In the Matter of the Application of	)	Docket Nos. 50-390
Tennessee Valley Authority	)	50-391

WATTS BAR NUCLEAR PLANT (WBN) - REPLY TO REQUEST FOR ADDITIONAL INFORMATION REGARDING CARBON DIOXIDE AUTOMATIC FIRE SUPPRESSION SYSTEMS (TAC NO. M63648)

ENCLOSURE 1
WATTS BAR NUCLEAR PLANT (WBN)
REPLY TO REQUEST FOR ADDITIONAL INFORMATION

FIGURES 34, 36 & 37

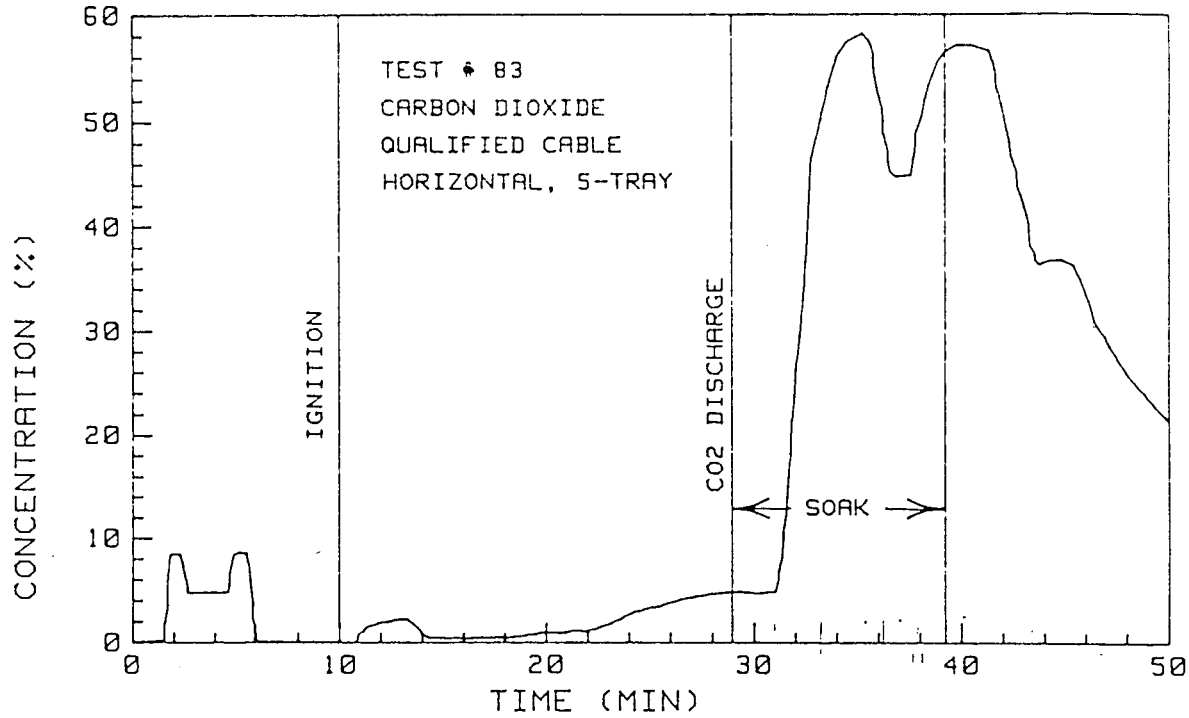
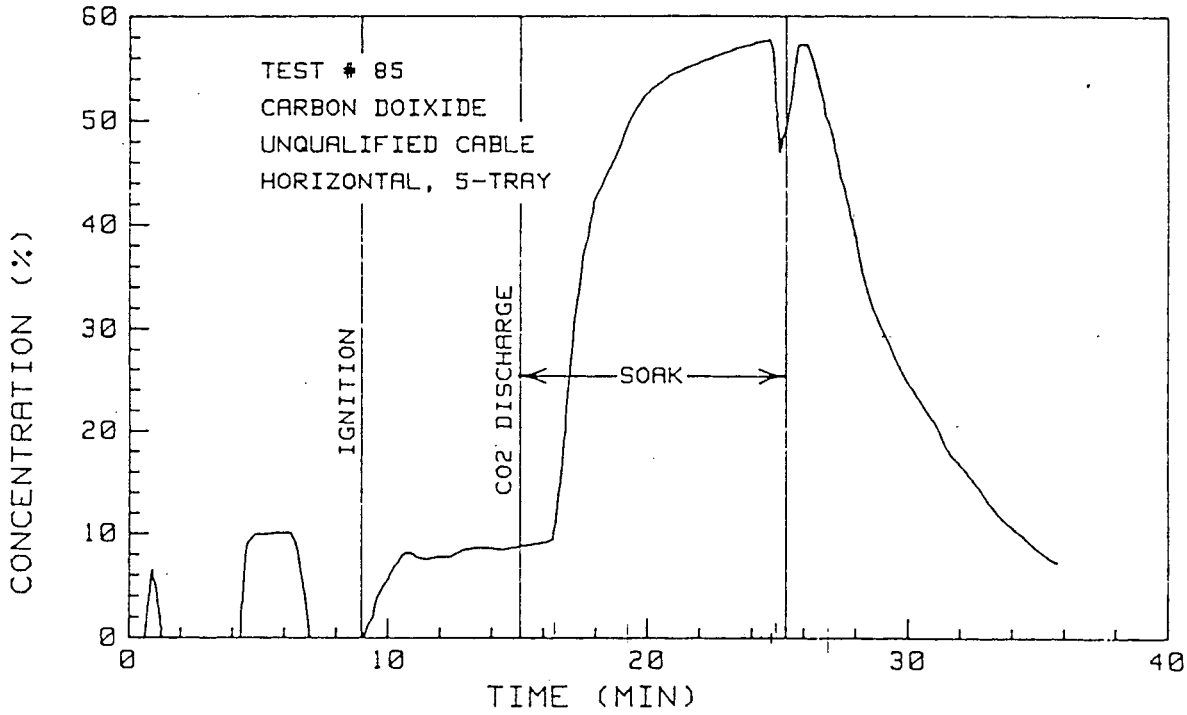
Also, it can be seen from the rapid decay of CO_2 shown in Sandia Figures 36 and 37 that the test room was not a tight room. In contrast, the WBN auxiliary instrument rooms are very tight and are able to maintain the CO_2 for a substantial period of time. A graphical representation of the Sandia test results overlaid with the WBN auxiliary instrument room discharge test (Attachment 4) shows that the WBN enclosure is much tighter that the Sandia

TEST RESULT OVERLAY

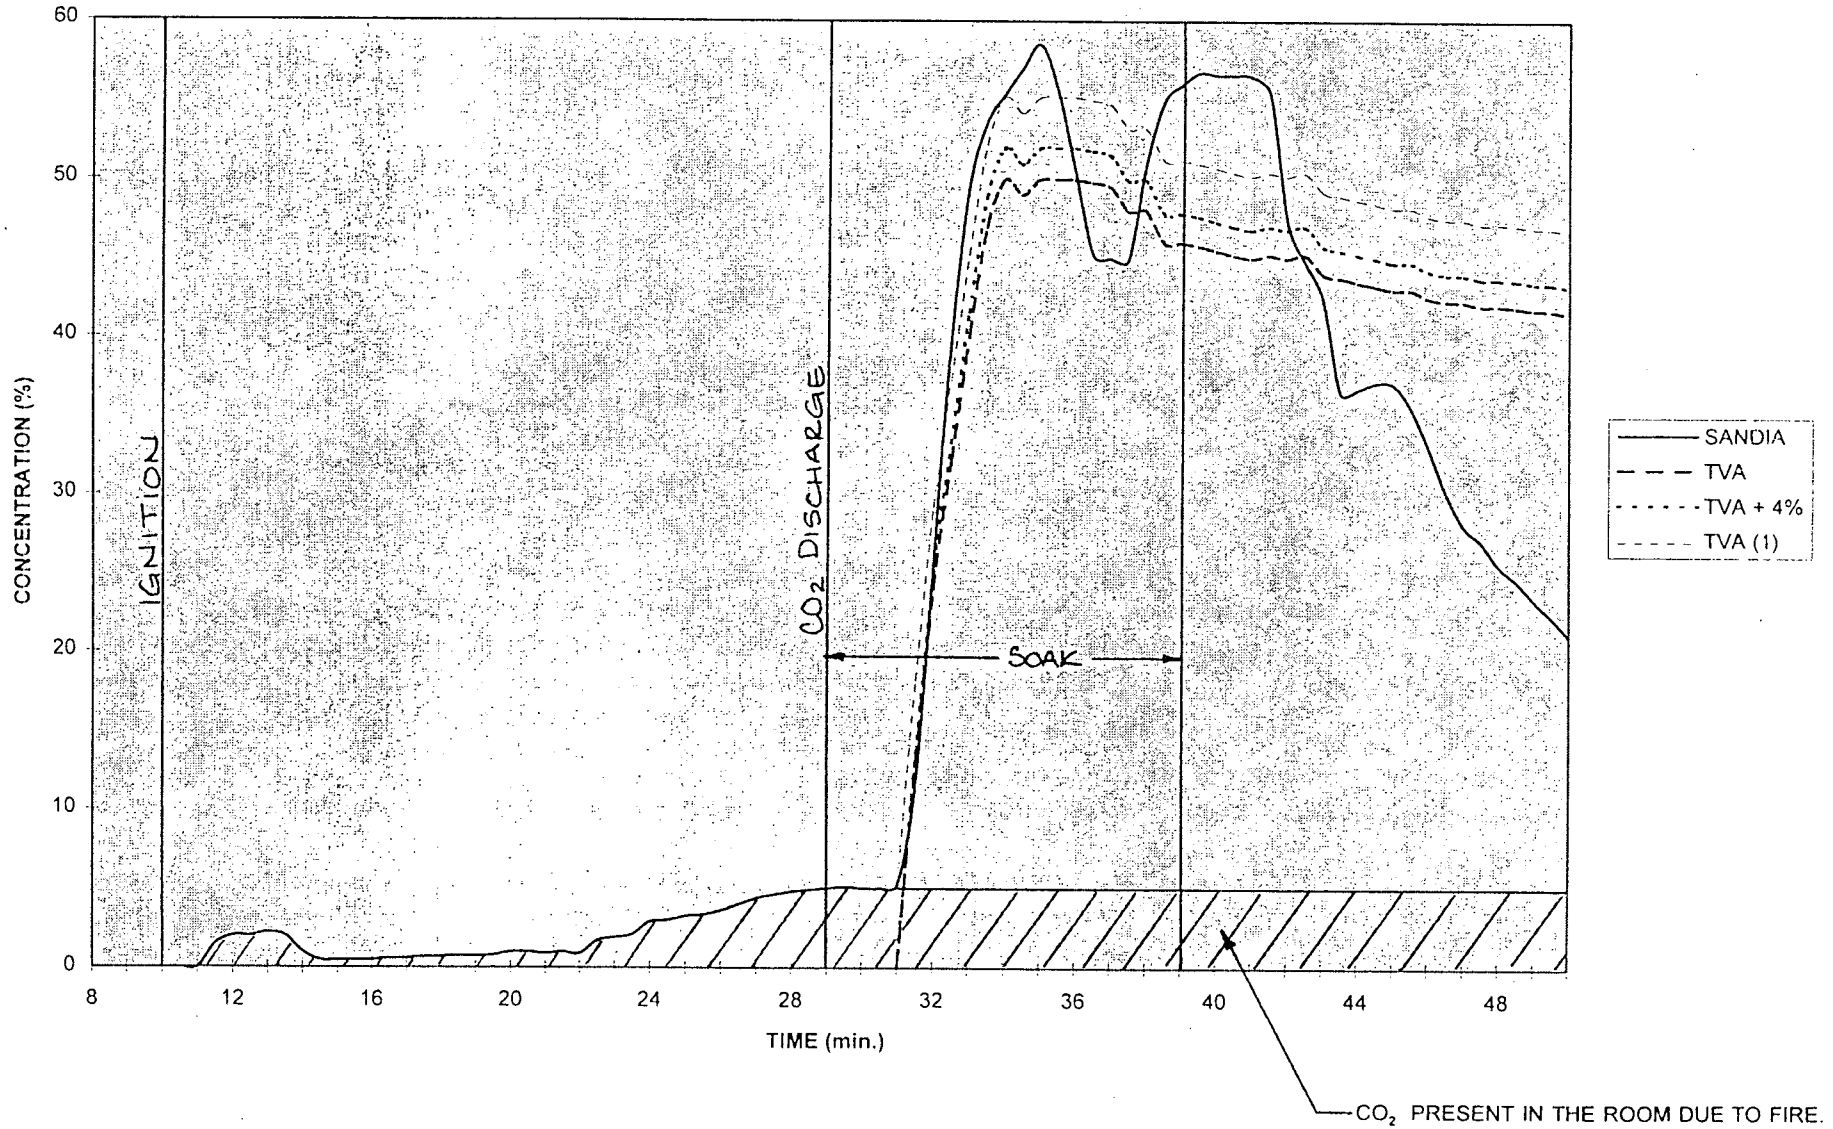
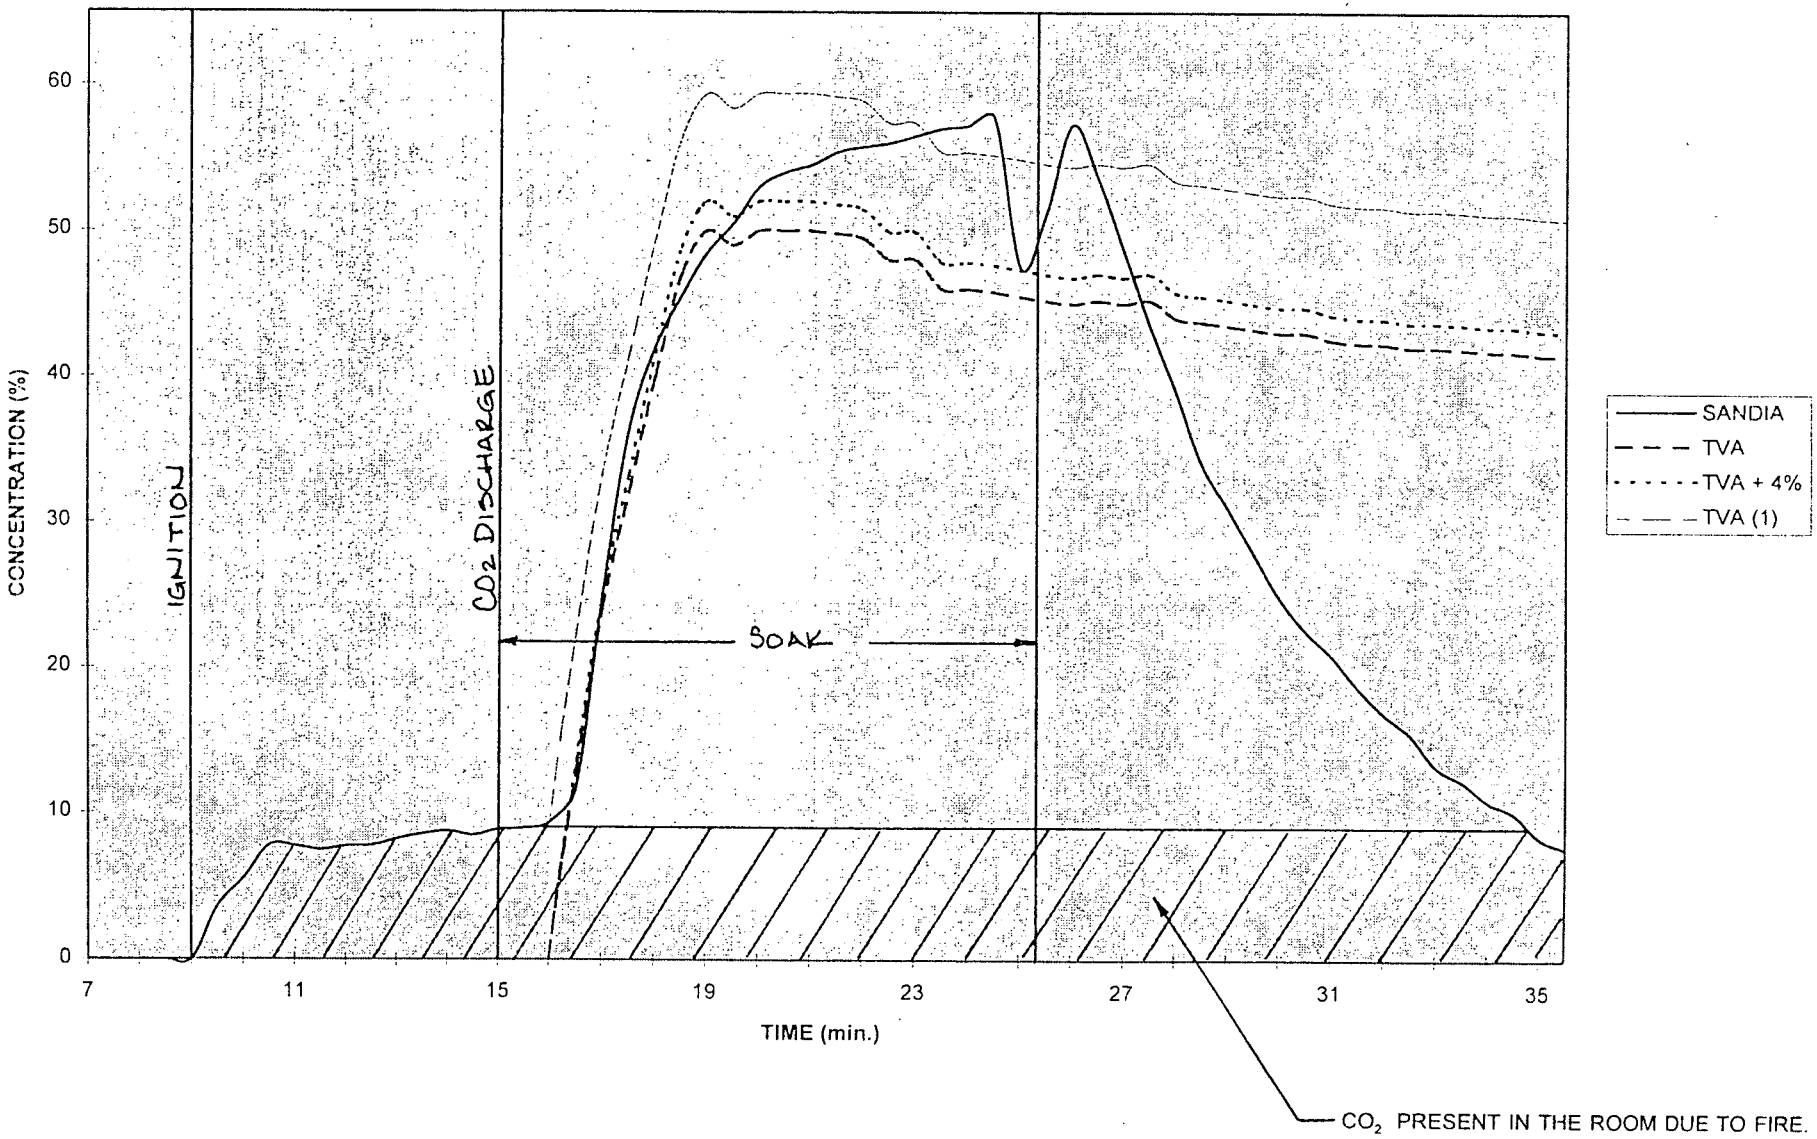
A graphical overlay representation of the Sandia test results and WBN Unit 2 auxiliary instrument room is shown in Attachment 4. Note that at the start of the discharge of CO_2 in the Sandia tests the room's CO_2 concentration was approximately 5%-9%. It appears that this initial contribution of CO_2 is due to the diffusion flaming combustion of the cables. This is consistent with the discussions of the physical chemistry of combustion in fires as presented by D.D. Drysdale in his book "An Introduction to Fire Dynamics." This additional CO_2 that is produced in an actual fire will contribute to the CO_2 system discharge and produce a synergetic effect on smothering the fire (i.e., reducing the oxygen content of the atmosphere by dilution to a level where the atmosphere no longer will support combustion). As noted, the WBN test results, with the additional CO_2 that would result from the timer increase, ensures a sufficient concentration for extinguishment as bounded by the Sandia tests. Therefore, the performance criteria of NFPA 12-1973, Section 2523 have been met and adequate concentration levels and soak times have been accomplished.
